Item ID: D206-667-107BL Accept ***N900040100*** Setup Start ***NS1***
Revision ID: Stop ***NS2***
Item Name: Fwd Crosstube - Mid Height 206L / L1 / L3 / L4, Blue
Start Date: 6/21/2017 Start Qty: 1.00 ***1*** Cust Item ID:
Required Date: 7/7/2017 Req'd Qty: 1.00 ***1*** Customer:
Reference:

DART AEROSPACE LTD		Work Order:	162187
Description: Crosstube Mid Fwd (206L)		Part Number:	D206-667-107
Inspection Dwg: D206-667-147	Rev: A	Page 1 of 1

DRAWING NO.	D206-667-147	TITLE	REV. A	DART AEROSPACE LTD ENGINEERING ORDER	D.E.O. NO.	D206-667-147-A-1	SHEET NO.	SHEET 1 OF 1	SCALE	NTS
DRAWN	AS	CHECKED	ASS	MFG. APPR.	APPROVED	DE APPR.	DATE	11.07.15	DATE	11.07.21

DRAWING NO. D206-667-147	TITLE CROSSTUBE ASS'Y (206L MID FWD)	REV. A	DART AEROSPACE LTD ENGINEERING ORDER		D.E.O. NO. D206-667-147-A-2	SHEET NO. SHEET 1 OF 1	SCALE NTS
DRAWN AJS	CHECKED	MFG. APPR. <i>E</i>	APPROVED <i>MD</i>	DE APPR. <i>MD</i>			
DATE 12.08.02	DATE 12.08.02	DATE 12.08.02	DATE 12.08.02	DATE 12.08.02	DATE 12.08.02

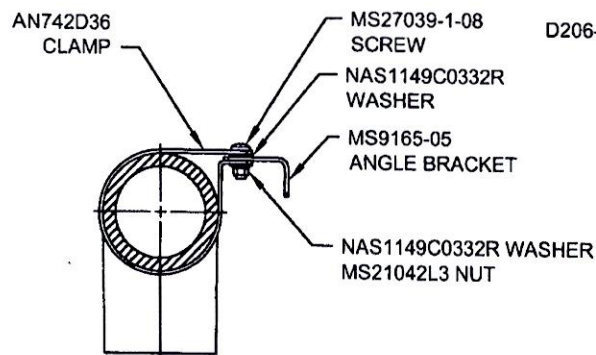
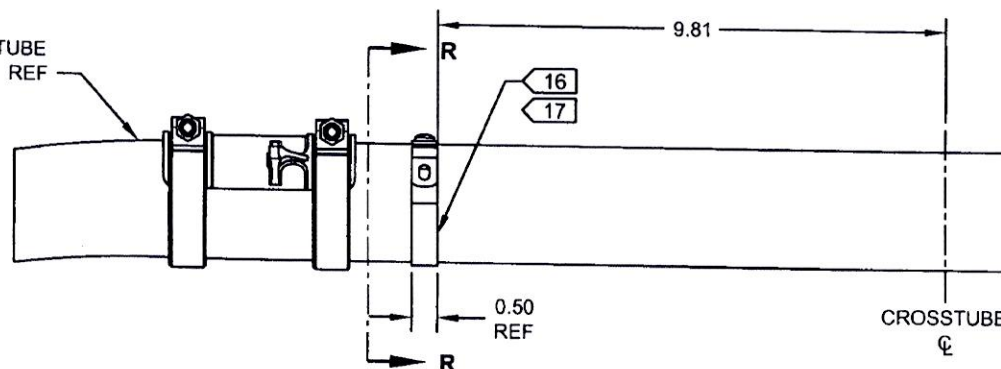
PURPOSE:

ADD ELECTRICAL GROUNDING STRAP

ITEM	QTY -147	PART NUMBER	DESCRIPTION
1	X	D206-667-147	CROSSTUBE ASSEMBLY (206L MID FWD)
10	2	AN742D36	CLAMP
11	2	MS9165-05	ANGLE BRACKET
12	2	MS21042L3	NUT (OR MS21042-3)
13	2	MS27039-1-08	SCREW
14	4	NAS1149C0332R	WASHER (OR AN960C10L)

- 16) MASK AREA UNDER CLAMP PRIOR TO PAINTING
 17) SEAL EDGES WHERE AN742D36 CLAMP MEETS WITH THE CROSSTUBE USING SIKAFLEX-241/-291 OR MIL-S-8802 CLASS B2 OR PROSEAL 890 SEALANT
 18) PERFORM RESISTANCE CHECK TO ENSURE MAX RESISTANCE IS 10 MILLIOHMS

DETAIL P
 BONDING STRAP INSTALLATION 2 PL
